SURRY POWER STATION, UNIT NO. 1

AMENDMENT TO FACILITY OPERATING LICENSE

Amendment No. 44  
License No. DPR-32

SUPPORTING AMENDMENT NOS. 44 AND 43 TO  
FACILITY LICENSE NOS. DPR-32 AND DPR-37

**VIRGINIA ELECTRIC AND POWER COMPANY  
SURRY POWER STATION  
ORGANIZATION CHART**

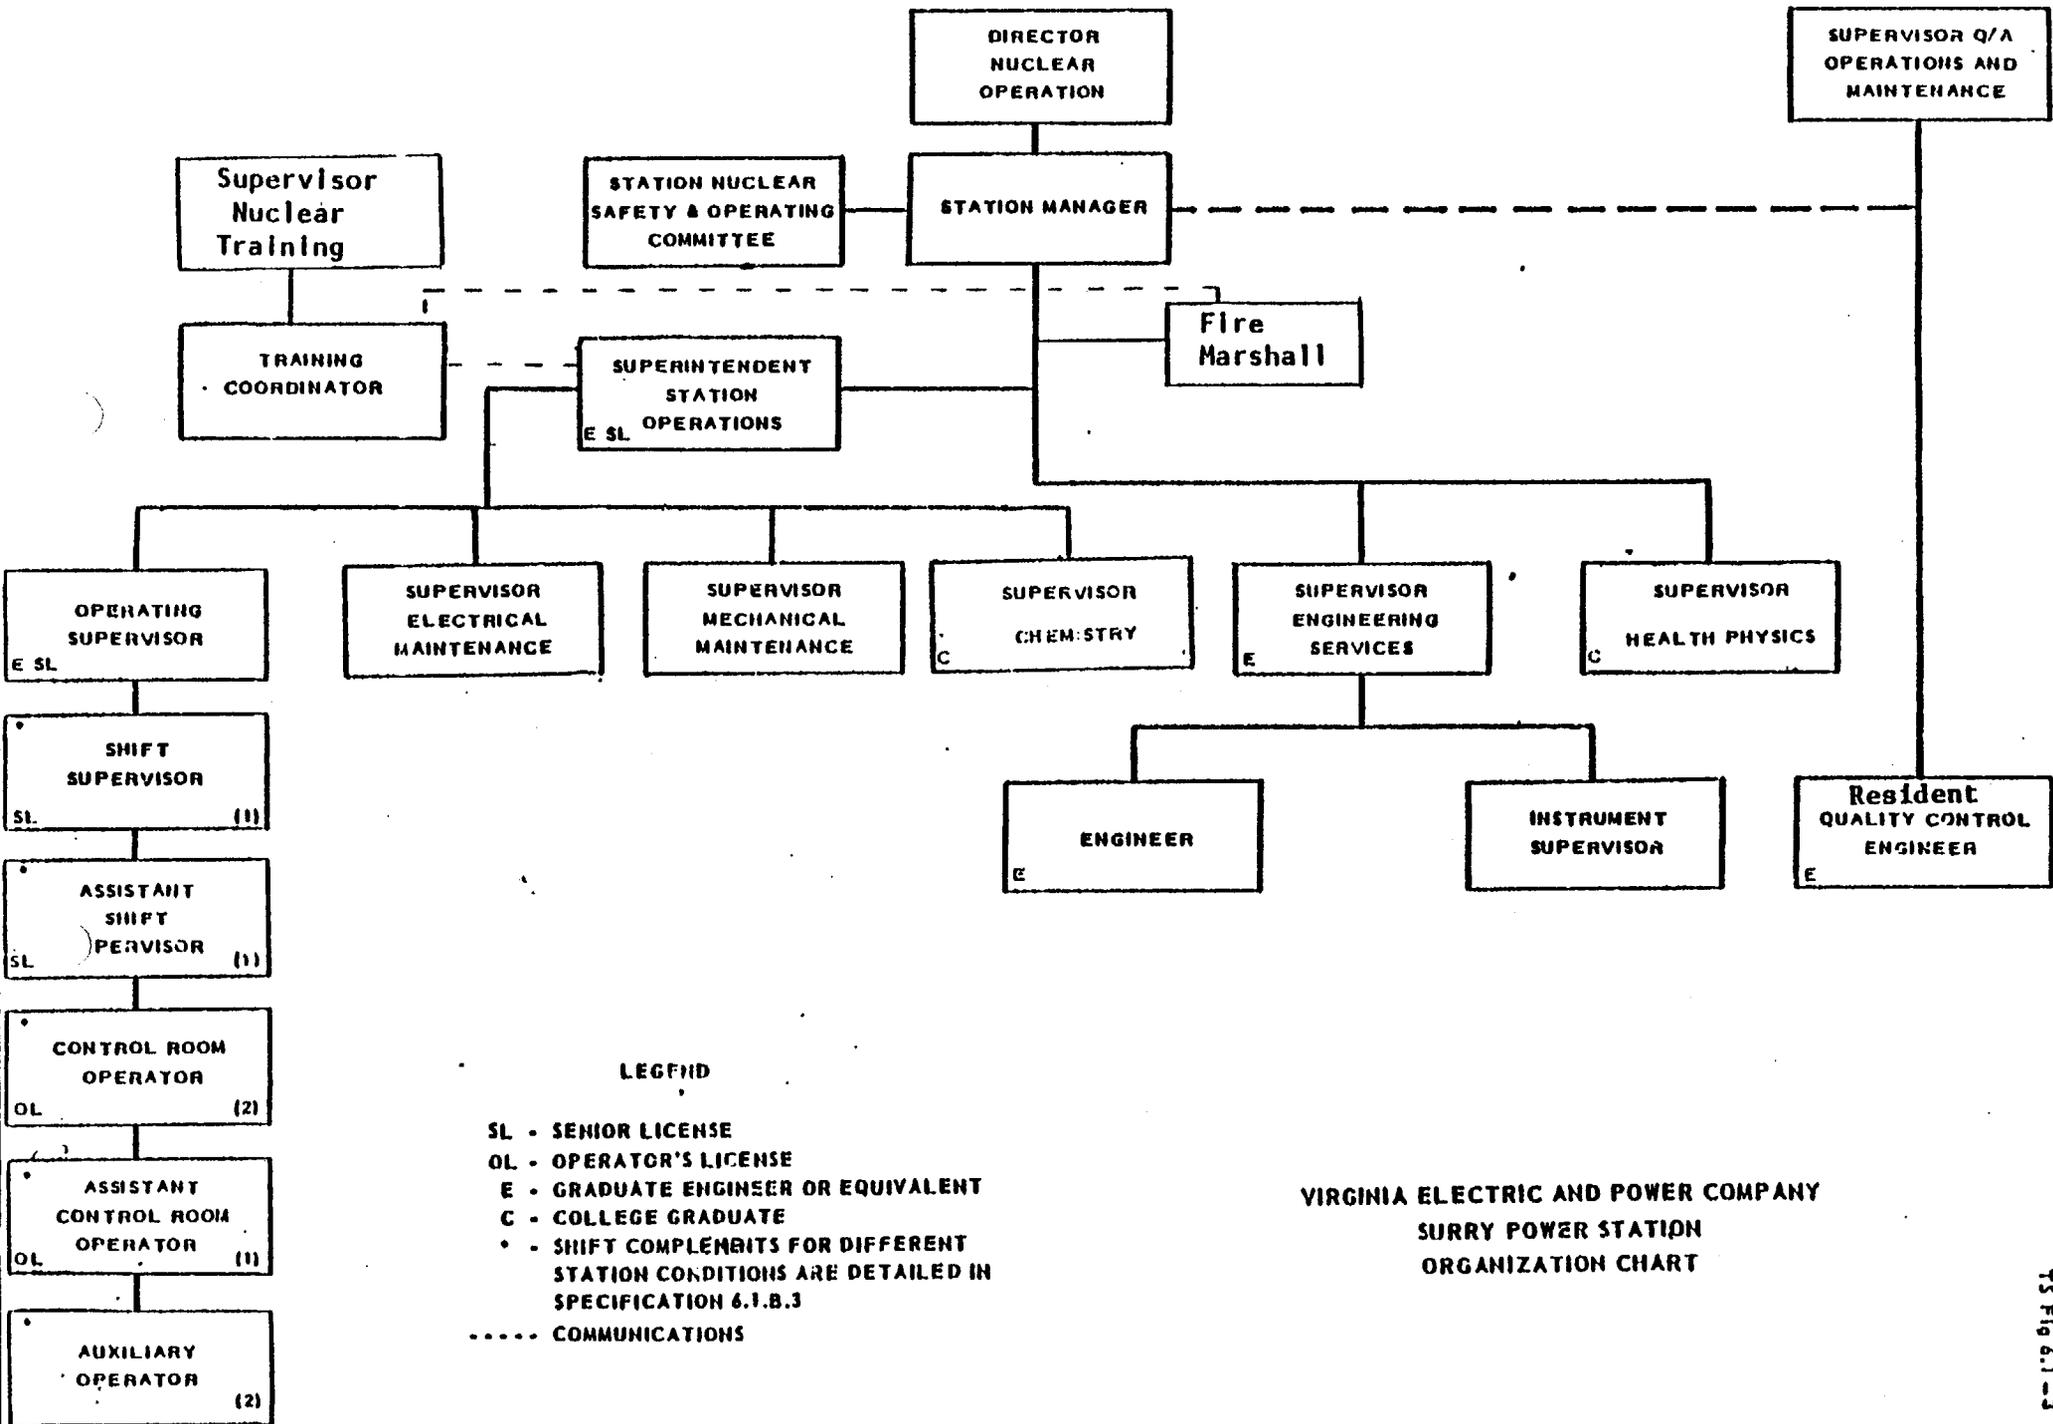
These changes to the Technical Specifications, (1) reduce the allowable pressurizer heatup rate from 200°F/hr to 100°F/hr, (2) reflect a new title of "Resident Quality Control Engineer" to replace "Quality Control Engineer," and (3) correct a typographical error on page TS 3.16-2 which was issued on May 10, 1978.

With regard to the title change adding "Resident" to the position of Quality Control Engineer, this is a title change only. There has been no change identified on the required degree of independence of this position. We therefore view this as a non-substantive change, which is acceptable.
